Peacocke Strategic Transport Project

Detailed Design Road Safety Audit

Prepared for: Hamilton City Council

Date : January 2020
Reference: 232891.00
Status: Final

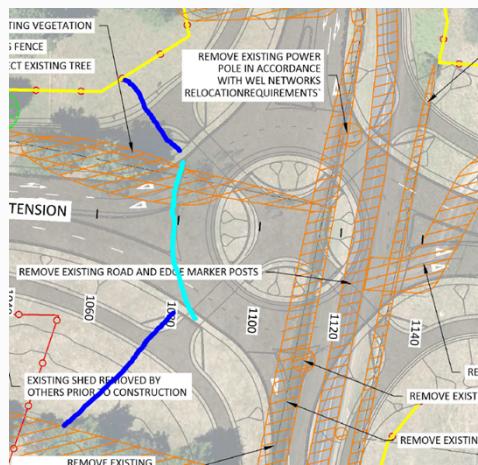
The drawings show that works for the Ring Road Extension terminates at the North/South Arterial Intersection but there are no details of this intersection layout provided. However, we understand that this is not noted within the NLTP (i.e. within 10-year timeframe) and the intersection form has not been determined. If the ring road extension does terminate at this location, there is no signage indicating the road ends or provision to turn. In addition, the SAT are concerned about CPTED in these locations, with potential for a 'dead-end' road being open with free access leading to anti-social behaviour/boy-racers congregating, safety issues and potential damage to infrastructure / etc.

Provide turning facilities and signage to ensure drivers are aware of the road termination. Consider measures to reduce the potential for anti-social behaviour in this location.

Safety Engineer:	Click here to enter text.	
Client Decision:	Agree with both the SAT and the Designers response. If the extension can not be connected we would prefer that the whole area is isolated, by way of fencing or temporary barriers, rather than leaving a short stub for anti-social behaviour. Suggested barrier locations are illustrated in the image below.

Action Taken: Based on the uncertainty of future development timing, the fencing of this area will be determined toward the end of construction. Should no connection be in place, temporary fencing/barriers will be installed as indicated in the client decision with the option of providing a pedestrian/cycle connection to the existing network.

DRAWING
PEACOCKES ROAD -
WESTON LEA DRIVE EAST
INTERSECTION ENLARGEMENT PLAN

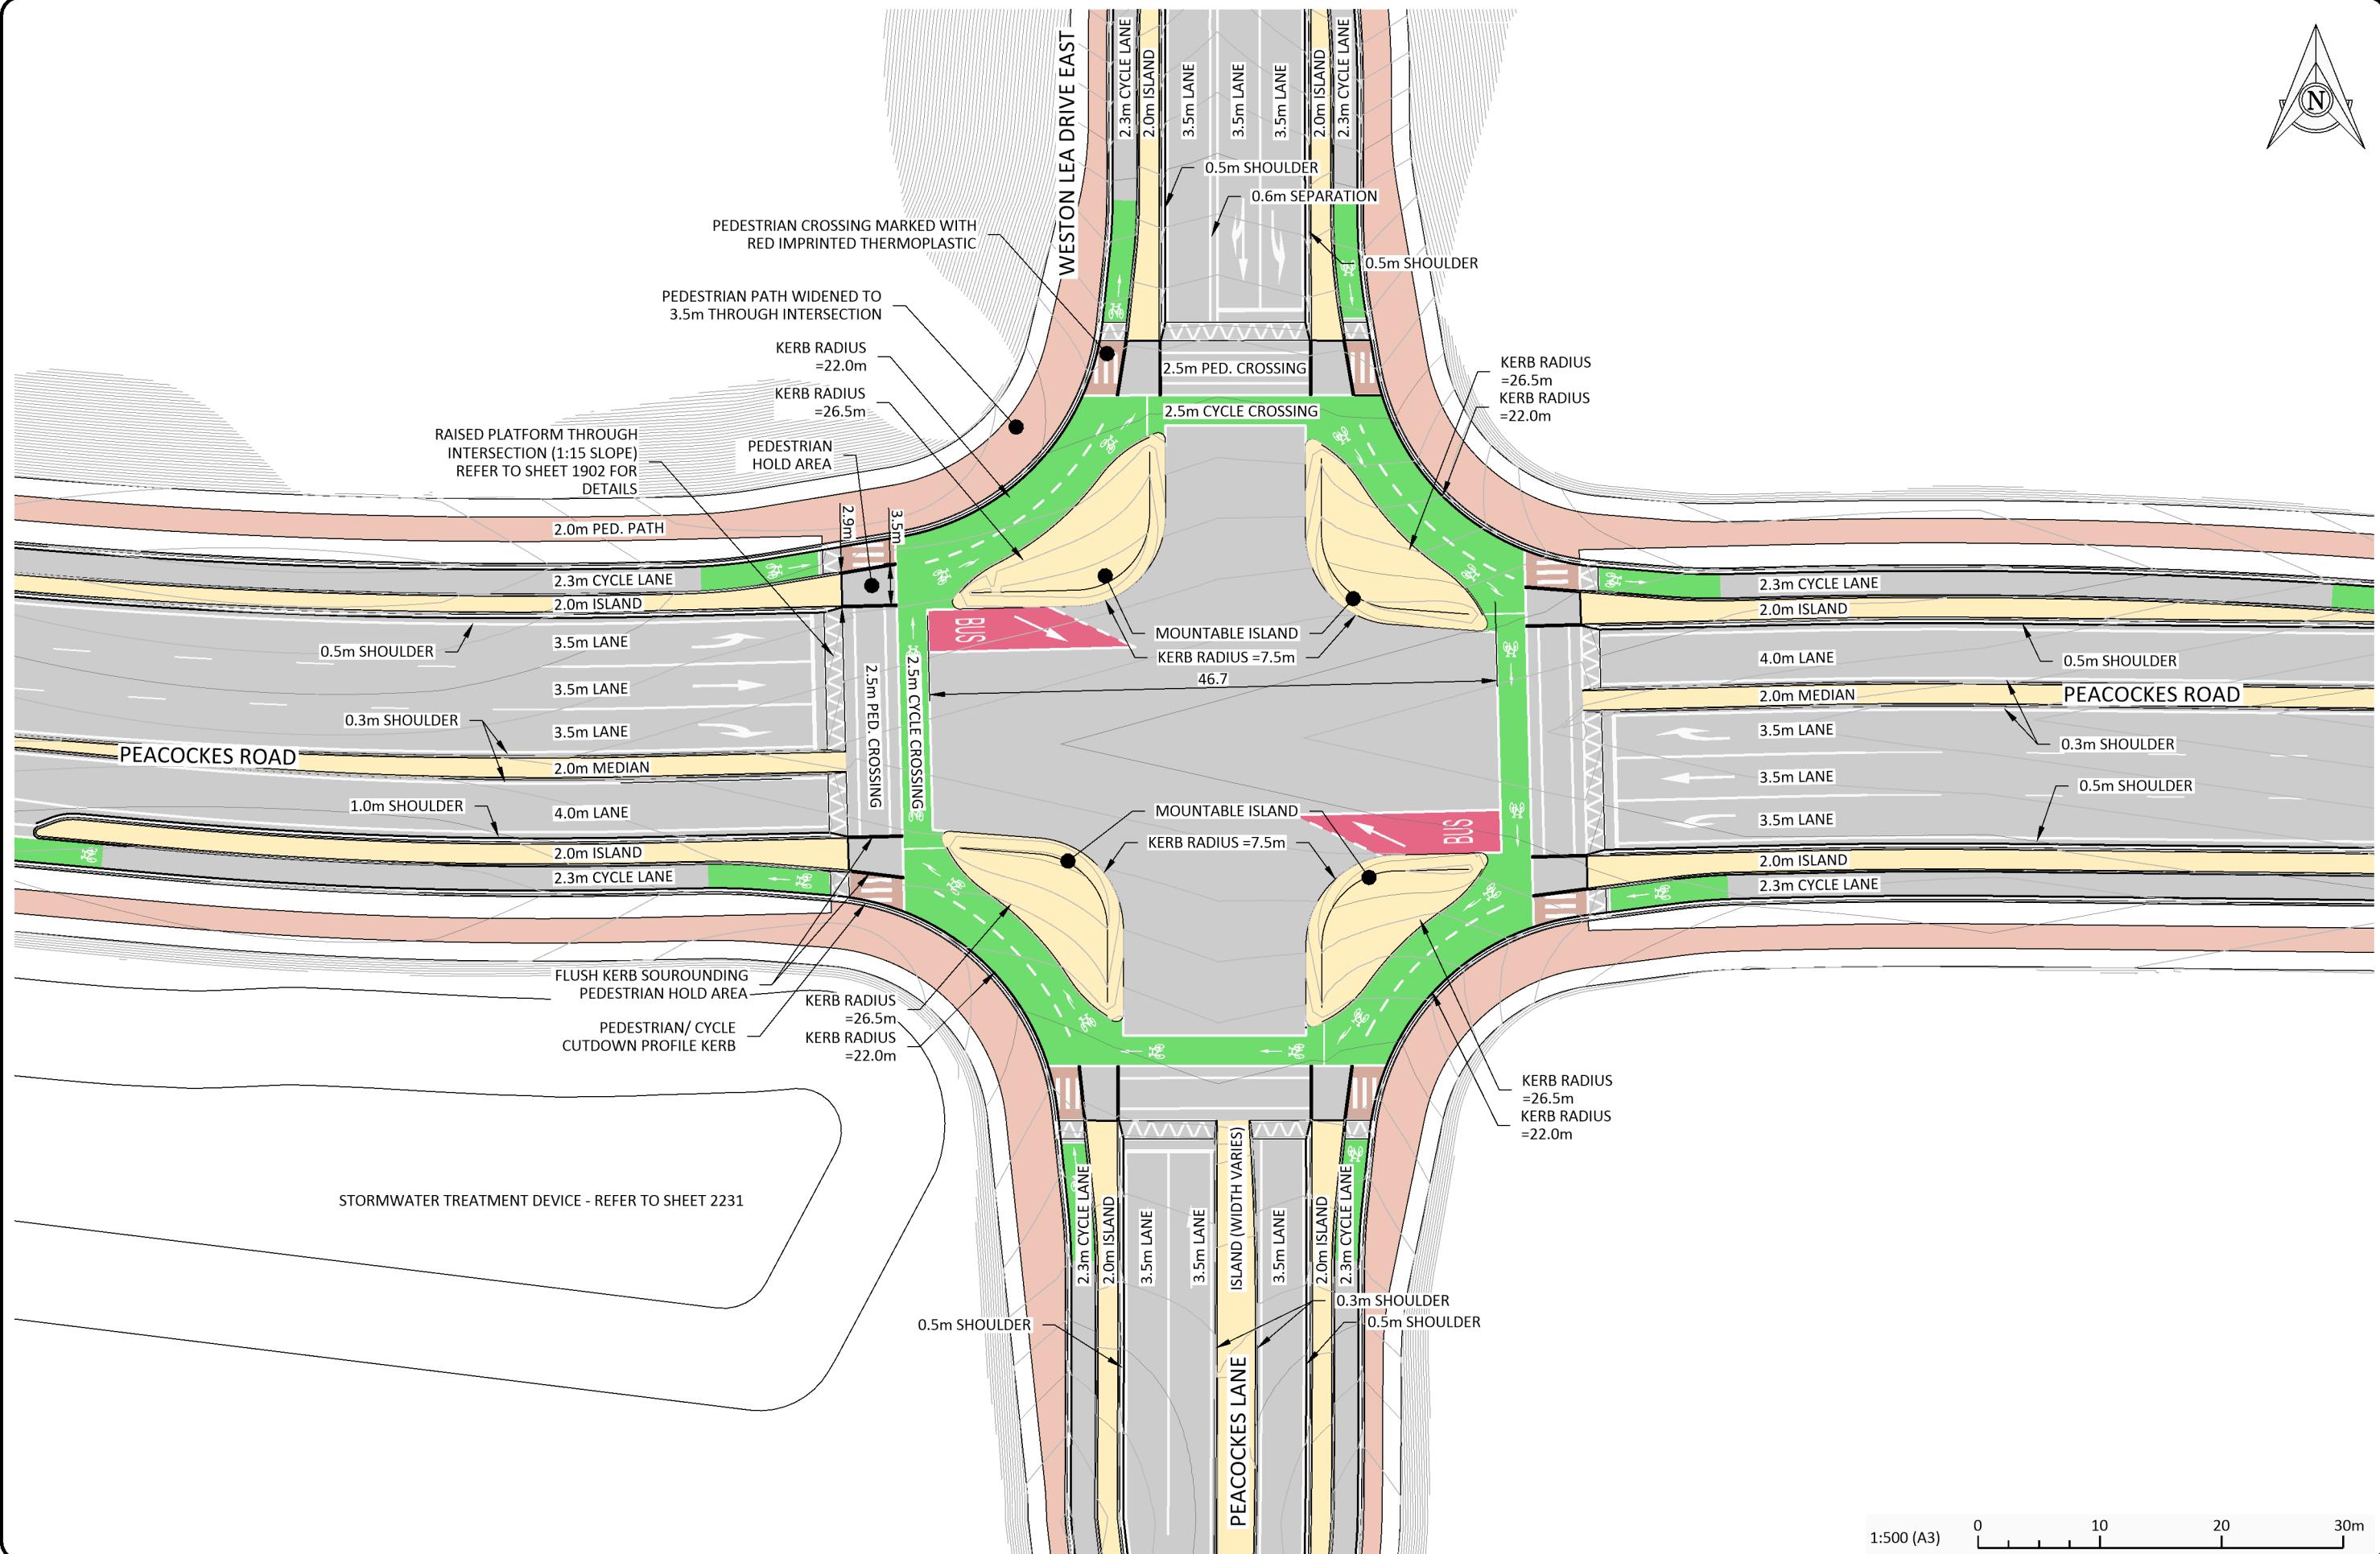
- 1 The intersection shows small physical islands in each corner of the intersection to aid cyclists and ensure they use the cycle crossing facilities at the intersection. The SAT noted the following issues associated with the design: It appears that the shape of the islands will mean they are likely to be regularly hit by left turning vehicles (particularly HCVS).
- 2 The signals design relies on loops to detect cyclists, but the pavement markings do not show limit lines where cyclists should stop. Cyclists turning right turn are required to carry out the manoeuvre as a two stage (hook turn) movement but this movement is not intuitive with the current markings. The photo shop drawing below shows a similar layout that has been used for a similar intersection in Australia.

3 The cycle lanes on all the entries and exits from this intersection are not marked. In order to minimise confusion and ensure cyclists use the physically separated lanes, the lanes should have green background with cycle symbols.

- 1 Investigate removing the islands and if they are required ensure they are redesigned and do not impede the turning paths of HCVs.
- 2 Modify the intersection cycle lane pavement markings to include limit lines and right turn arrows to make it clear to cyclists where they should stop and how they should be making the right turn movements. As this intersection layout is a new concept, in conjunction with the physical works, consider what other measures could be implemented to inform road users how the facilities should be used. Ensure the traffic signal phasing caters for the cycle right turn movements and include dedicated aspects; and
- 3 Mark all the cycle lane entries and exits from this intersection with green background and with cycle symbols.

Designer Response: The designer acknowledges the SAT comments regarding this intersection. The intersection design has been amended and the footprint of the intersection increased to address the SAT concerns, as described below (reference also made to Sheet 1255 attached):

1. The islands have been designed with a mountable profile for large vehicles (i.e. 18m semi-trailers). Smaller vehicles (such as buses) will track within the carriageway without mounting the islands. Additional edgeline markings are now provided for guidance.
2. The designer agrees with the SAT and the plans have been amended to show directional markings similar to the example provided. Signal phasing has been adapted to provide enhanced prioritisation toward cyclists, including cycle-dedicated aspects.
3. The designer agrees with the SAT and plans have been updated.

Action Taken: As per Client's decision, the design has been updated as per designer response and subsequent discussion with the HCC Safety Engineer (and various experts, including NZTA). Concerns raised by the SAT have been resolved.
